INFORMATION BULLETIN

**Throttle Potentiometer –
Supersedes To Later Version**

MODEL XJS (5.3L)
VIN see text

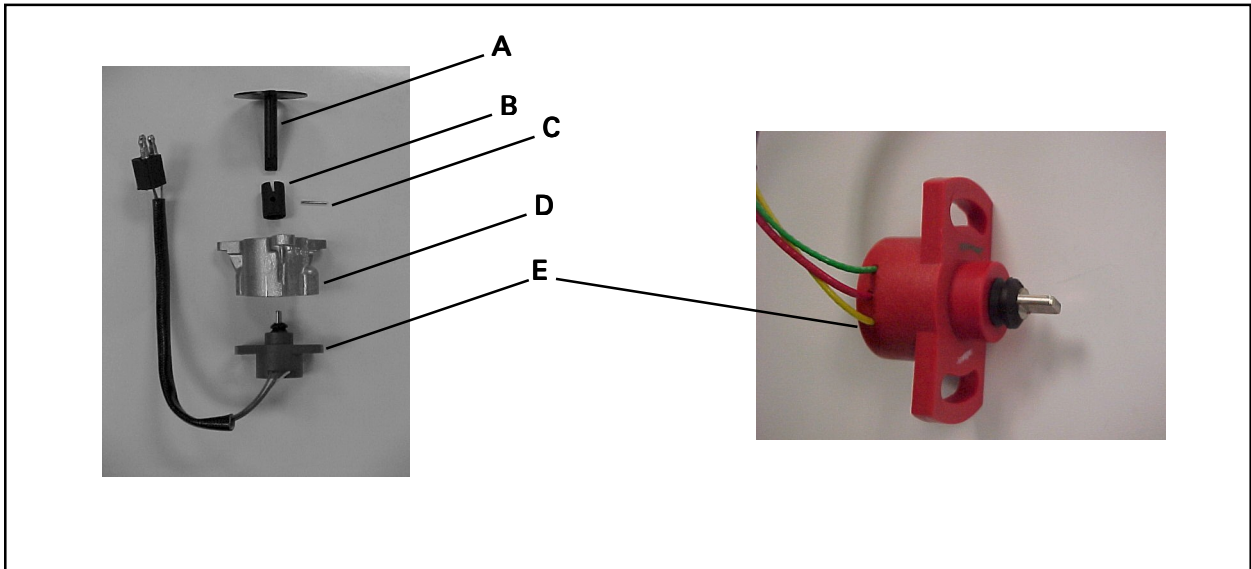
The Bourne (black) throttle potentiometer (EAC 2670) used on engines from engine no. 8S16400-8S61794 is no longer available. Vehicles requiring a new potentiometer should be updated to the later Lucas (red) throttle potentiometer. This modification requires all the parts listed below.

ILL #	PART NUMBER	DESCRIPTION
A	EBC 3566	Spindle
B	EBC 3568	Coupling
C	PA 103161/J	Spring Pin
D	EAC 9567	Adapter Housing
E	EAC 9634	Potentiometer
